The Agua Dulce Residential Project

Agua Dulce Town Council meeting

- Disclosures from Public Works re 20" water main project
 - Why was future Phase 2 water infrastructure located on Phase 1 removed from the plans for the on site water main during the plan check process?
 - How and why were the replacement bonds for the 20" main along Sierra Hwy and Valley Sage Road discounted and by whom?
- Next steps

TR 50385-01 watermain plans WWD 37-181

3483 PZ Phase 2 watermains 08 Apr 2021

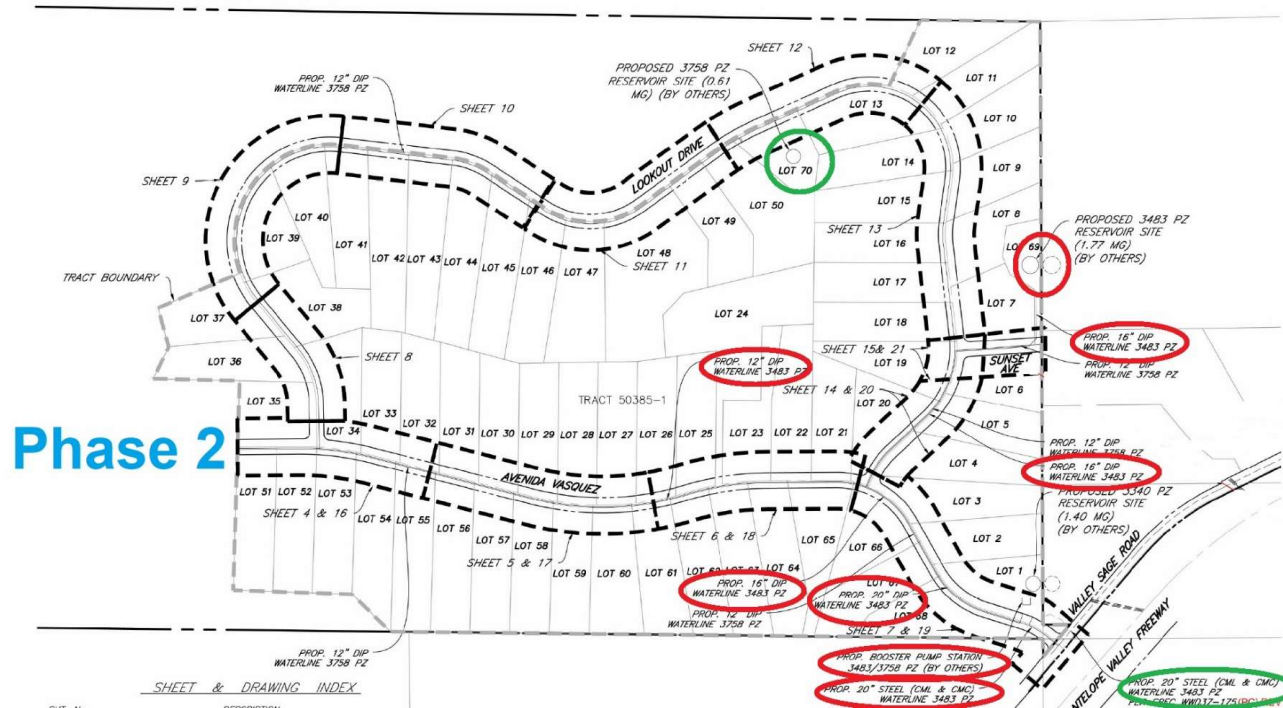
Good morning Nick – Could you consider removing the 2,200 feet of 3483 PZ watermain from the scope of 37-181(PC)? Since only the 3758 tank is being built in Phase I, and with all the hurdles that this project is facing, we're not sure how long it will take before Phase II can be built and we'd rather have this line built if and when Phase II comes in. Let us know your thoughts.

Good morning Nick - After discussing this further internally, we request the removal of the 3483 PZ watermain from the plans. It isn't beneficial for the district to have an unused water main sitting there until Phase II is built.

- KWC Engineers protested that the developer would rather build it now rather than later. Building it [3483 PZ] now would avoid any physical conflicts with other wet and dry utilities, avoid cutting up the streets and avoid community traffic burdens.

3483 PZ Phase 2 watermains 31 May 2023

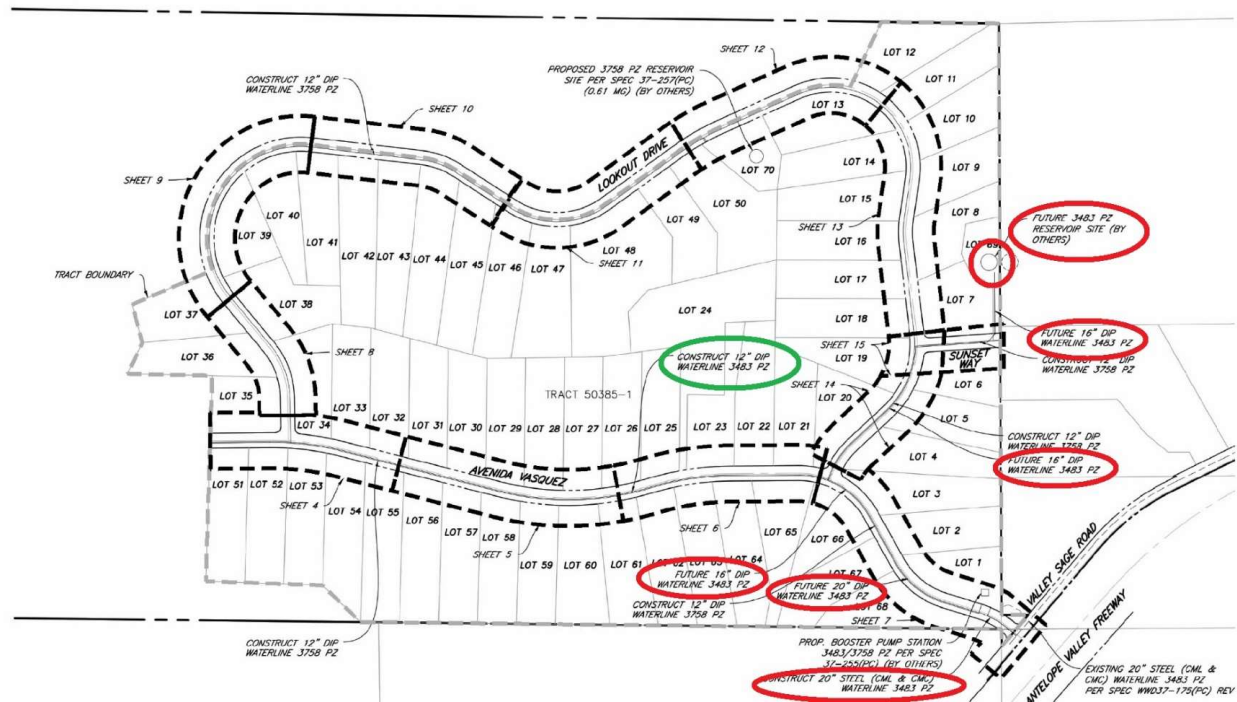
- KWC Engineers were directed to remove the future facilities (PZ3483) during plan check. **Can the Valley Sage water main bond be discounted as well?**
